PLAN COMMISSION MEETING AGENDA

MONDAY, FEBRUARY 26, 2024 AT 4:30 PM

TO: Plan Commission
DATE: February 26th, 2024
SUBJECT: 1722 S Church Street, Conditional Use Permit - CUP

Applicant is seeking approval of a conditional use permit for 'Indoor Commercial Entertainment' to bring an existing Culver's Restaurant into conformance with the zoning code, remodel the existing restaurant, and add an addition to the front of the building. The restaurant previously received a CUP to expand the drive-through into a double drive-through.

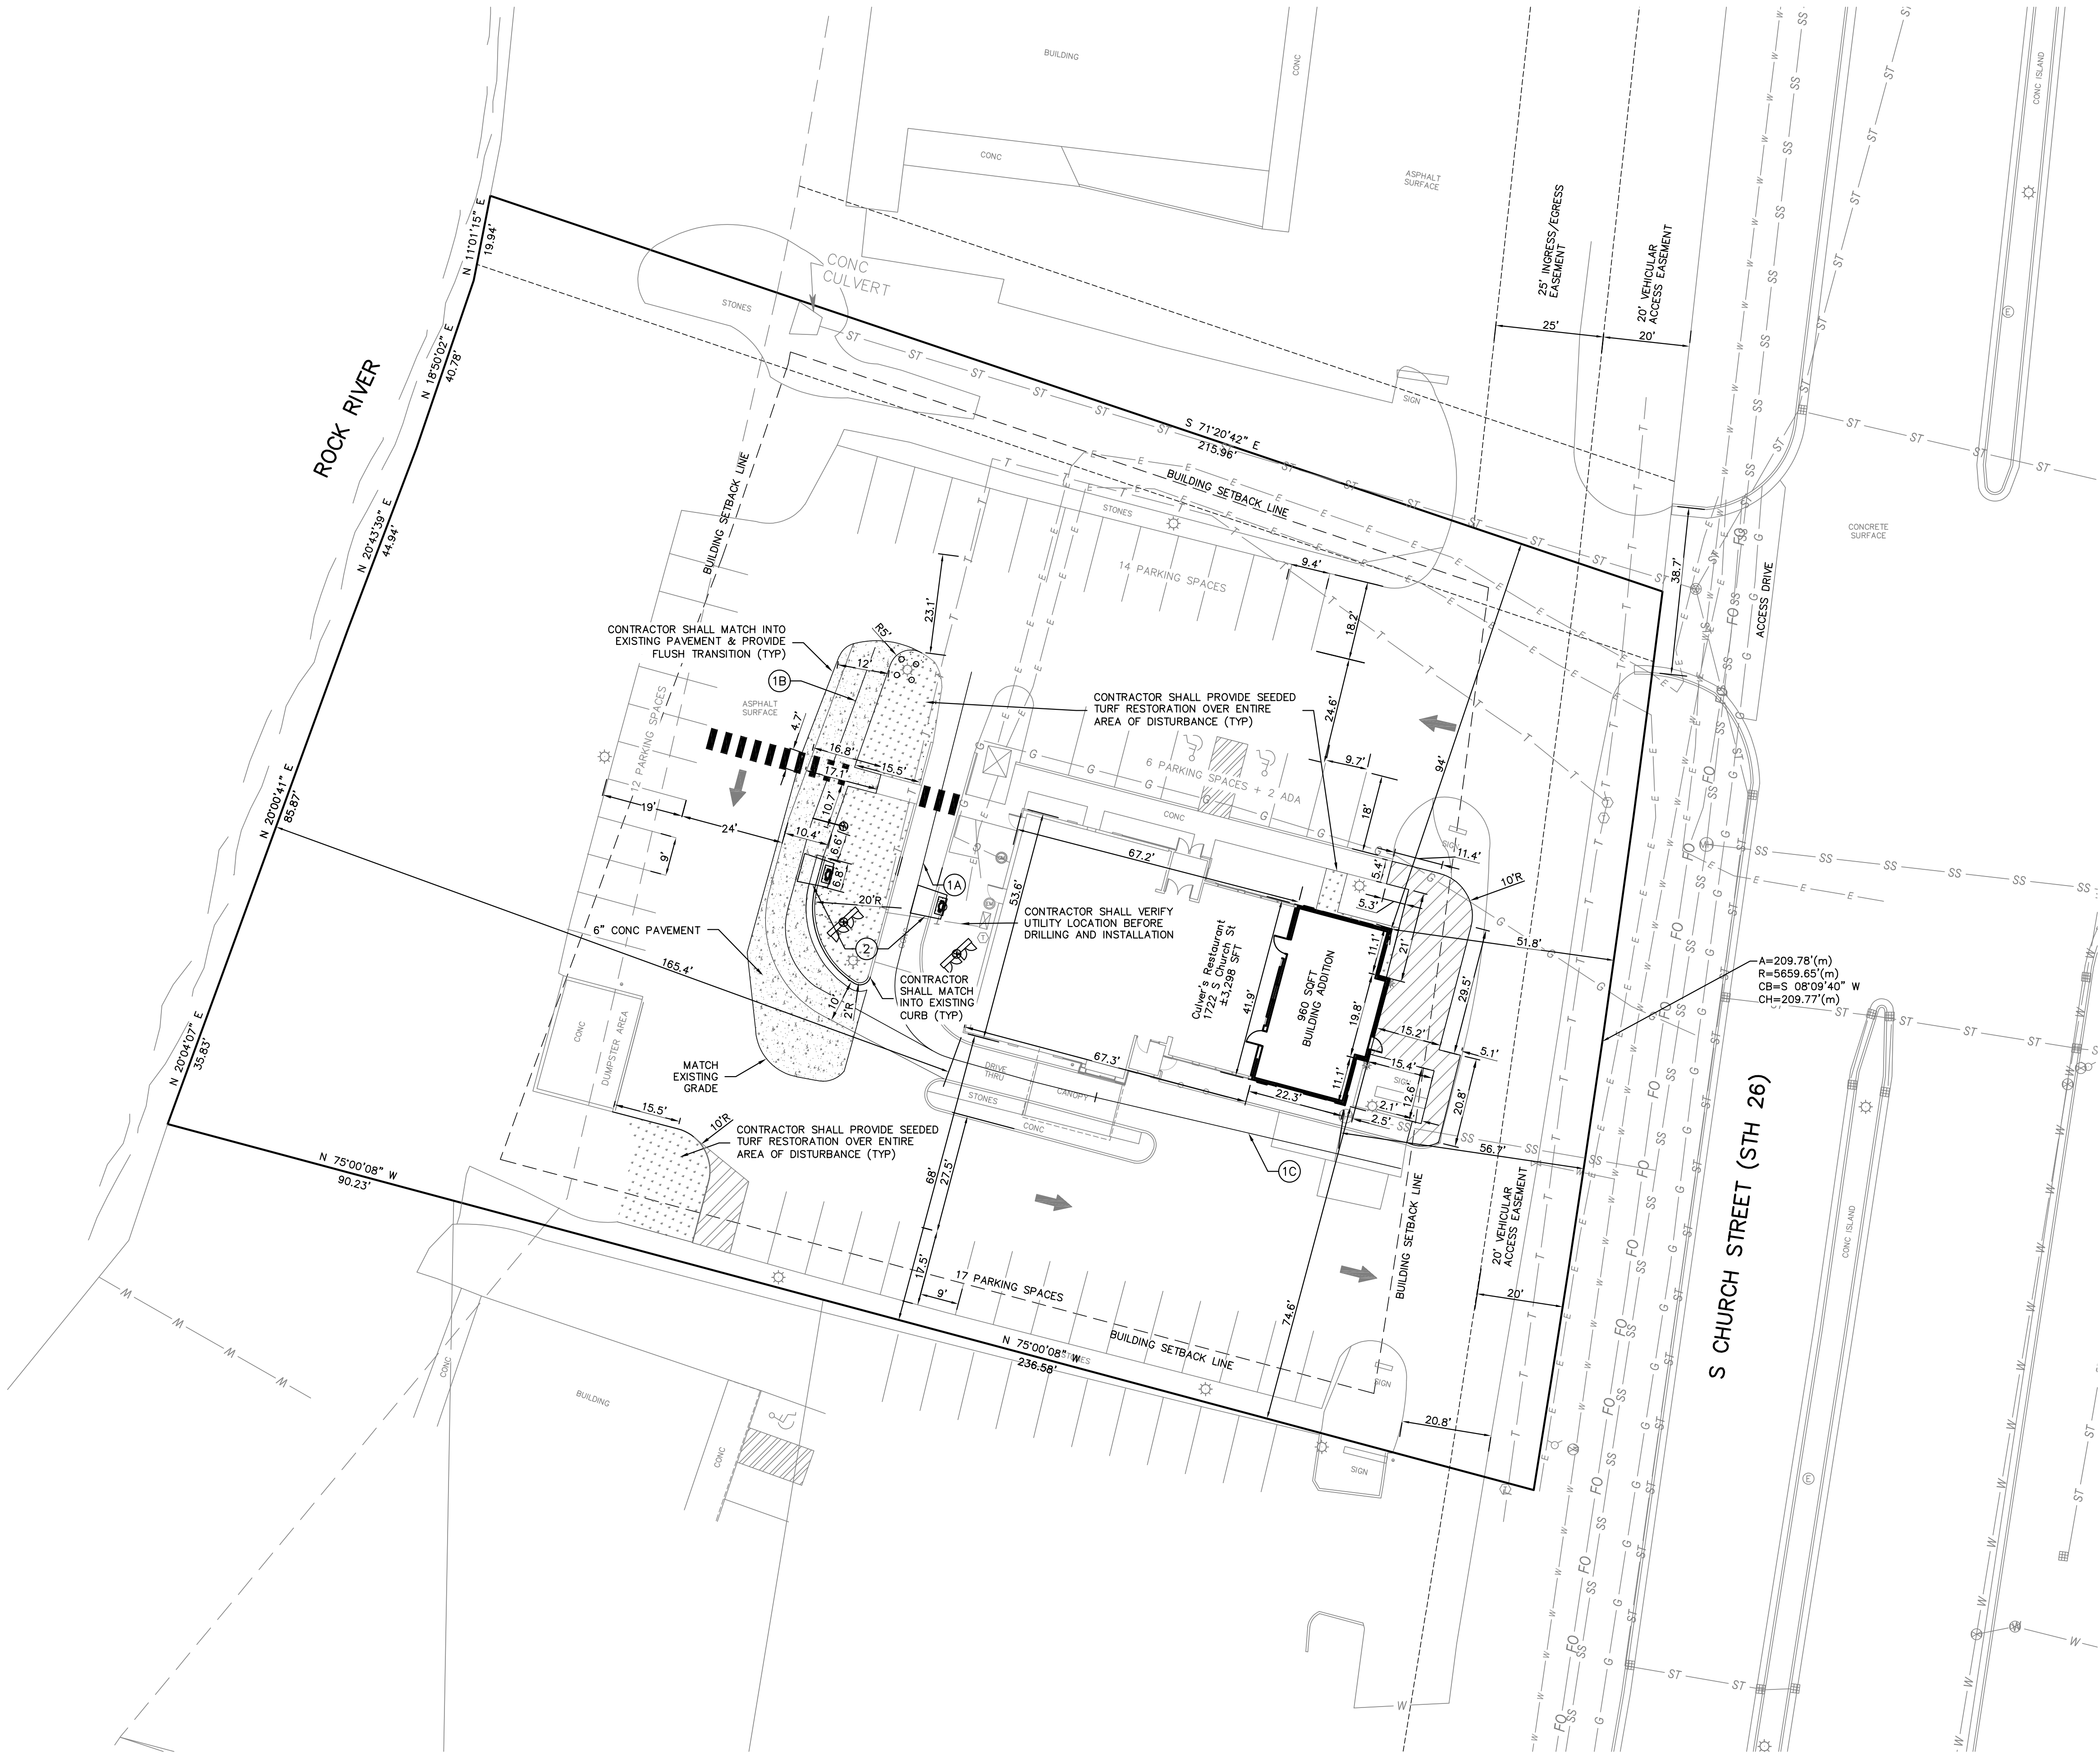
4. Landscaping requirements. Applicant has not submitted a landscaping plan meeting the point requirements of the zoning ordinance.
